# Proposed changes to P802.3dj MPI and DGD penalty specifications

John Johnson, Broadcom

Implementation details for P802.3dj D2.0 comments #15-35, 286-288

Figure 180-3—OMA<sub>outer</sub> each lane (max) and OMA<sub>outer</sub> each lane (min) versus max(TECQ, TDECQ)

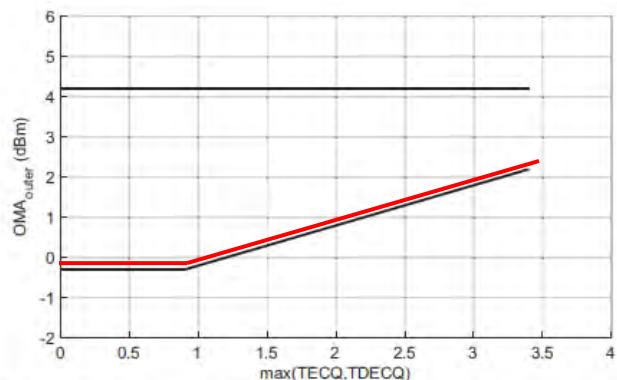
- Change the values in Table 180-7 as shown in red
- Update footnote b:
  - An average launch power of  $-3.1$  dBm corresponds to an OMA of  $-0.1$  dBm with an infinite extinction ratio.
- Update Figure 180-3 to match the changes to OMA<sub>outer</sub> in Table 180-7.

Figure 180-5—Transmitter OMA<sub>outer</sub> each lane versus max(TECQ, TDECQ) and receiver sensitivity (OMA<sub>outer</sub>) each lane versus TECQ

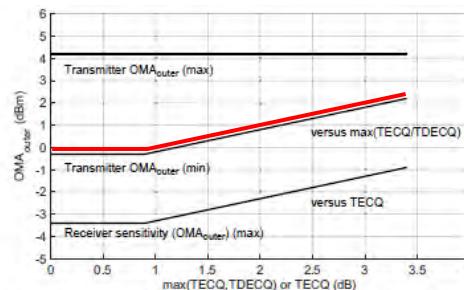
...includes an allocation of 0.1 dB for MPI penalty and 0.2 dB for DGD penalty. ... the allocation for penalties should be “6.7 – channel insertion loss”.
- Update Figure 180-5 to match the changes to TX OMA<sub>outer</sub> in Table 180-7.

Figure 181-3—OMA<sub>outer</sub> each lane (max) and OMA<sub>outer</sub> each lane (min) versus max(TECQ, TDECQ)

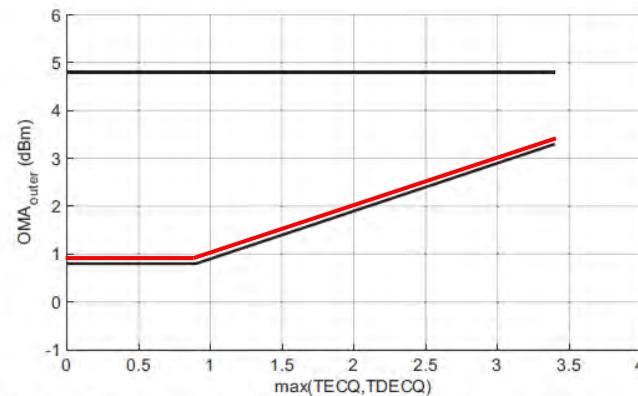
- Change the values in Table 181-5 as shown in red
- Update footnote b:
  - An average launch power of  $-2.1$  dBm corresponds to an OMA of  $0.9$  dBm with an infinite extinction ratio.
- Update Figure 181-3 to match the changes to OMA<sub>outer</sub> in Table 181-5.

Figure 181-5—Transmitter OMA<sub>outer</sub> each lane versus max(TECQ, TDECQ) and receiver sensitivity (OMA<sub>outer</sub>) each lane versus TECQ

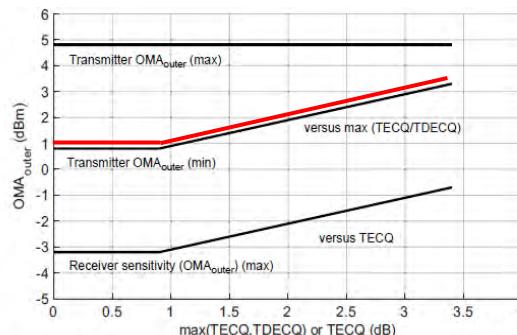
- Change the values in Table 181-7 as shown in red.
- Update footnotes b and c following the form of Table 180-9, with appropriate changes shown in red.
- Table 181-xx refers to the new table of maximum channel insertion loss to be added to CL 181.8.2.
- Update Figure 181-5 to match the changes to TX OMA<sub>outer</sub> each lane (min) versus max(TECQ, TDECQ) in Table 181-5.

Figure 182-3—OMA<sub>outer</sub> each lane (max) and OMA<sub>outer</sub> each lane (min) versus max(max(TECQ, TDECQ))

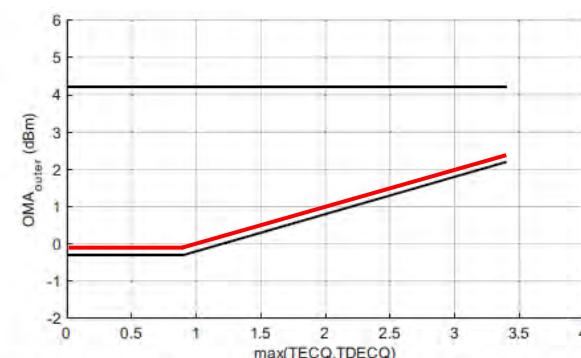
- Change the values in Table 182-7 as shown in red
  - Note that these are the same TX specs as CL 180 for component commonality
- Update footnote b:
  - An average launch power of **-3.1** dBm corresponds to an OMA of **-0.1** dBm with an infinite extinction ratio.
- Update Figure 182-3 to match the changes to OMA<sub>outer</sub> in Table 182-7.

Figure 182-4—Receiver sensitivity ( $OMA_{outer}$ ), each lane (max)

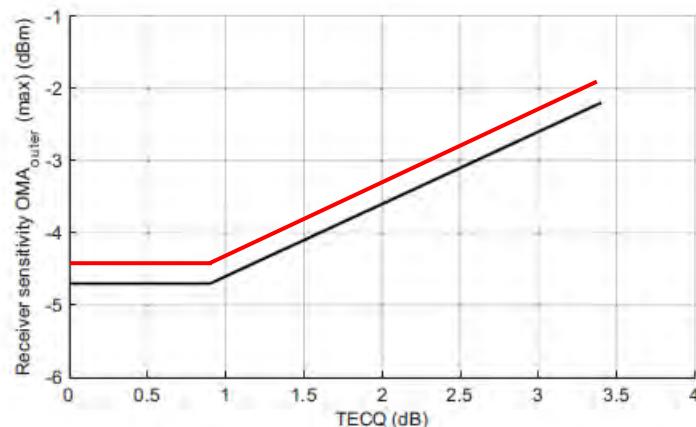
- Change the values in Table 182-8 as shown in red
- Update Figure 182-4 to match the changes to Receiver sensitivity ( $OMA_{outer}$ ) in Table 182-8.

Figure 182-5—Transmitter OMA<sub>outer</sub> each lane versus max(TECQ, TDECQ) and receiver sensitivity (OMA<sub>outer</sub>) each lane versus TECQ

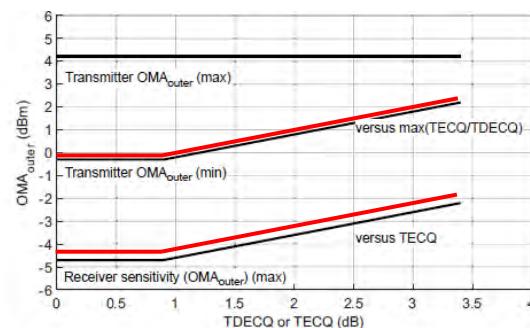
- Change the values in Table 182-9 as shown in red
- Update footnotes b and c following the form of Table 180-9, with appropriate changes shown in red.
- Table 182-xx refers to the new table of maximum channel insertion loss to be added to CL 182.8.2.
- Update Figure 182-5 to match the changes to OMA<sub>outer</sub> in Tables 182-7 and 182-8.
